Certificate of Appropriateness
2125 Van Hise

August 29, 2022

24 **PROPOSED PERSPECTIVE (from NW)**
Scale: 3/16" = 1'-0"

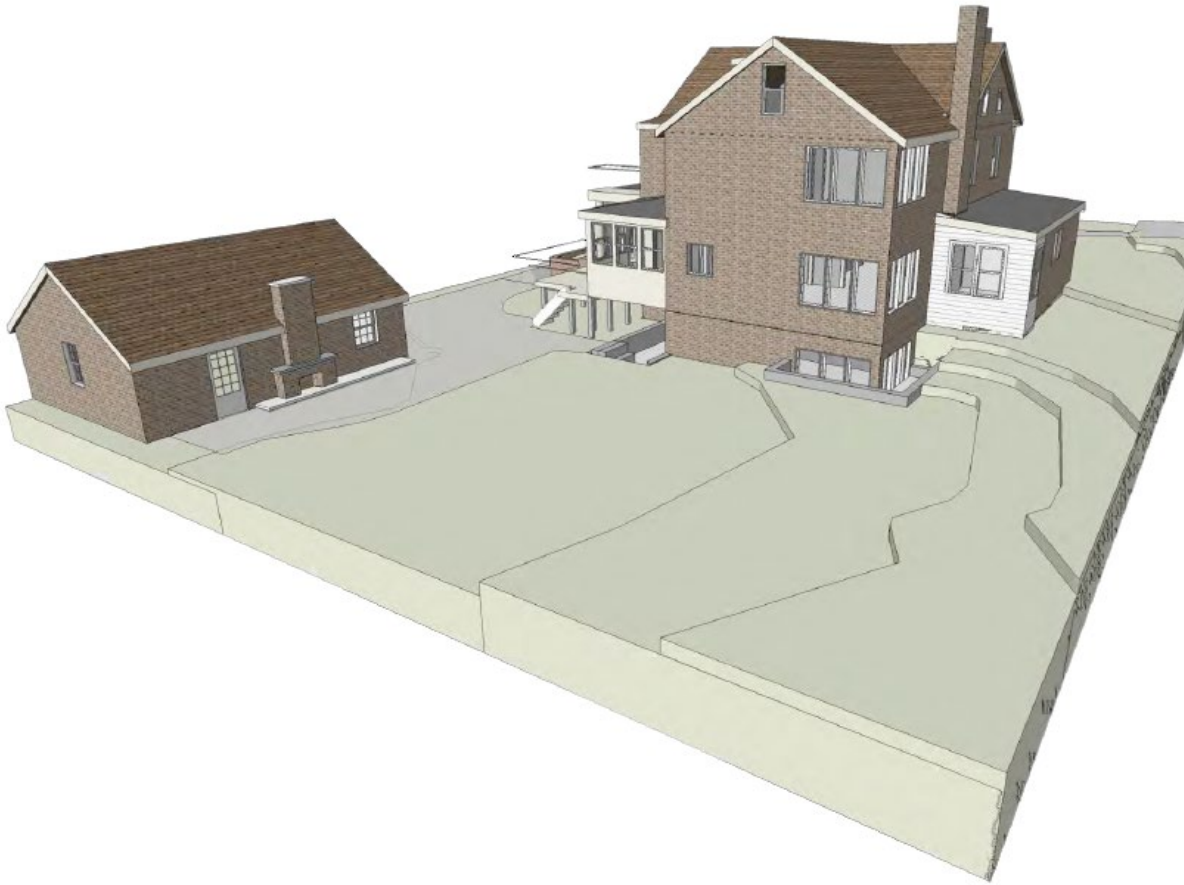
1. Modification of the bay window to be in keeping with the historic character of the building.
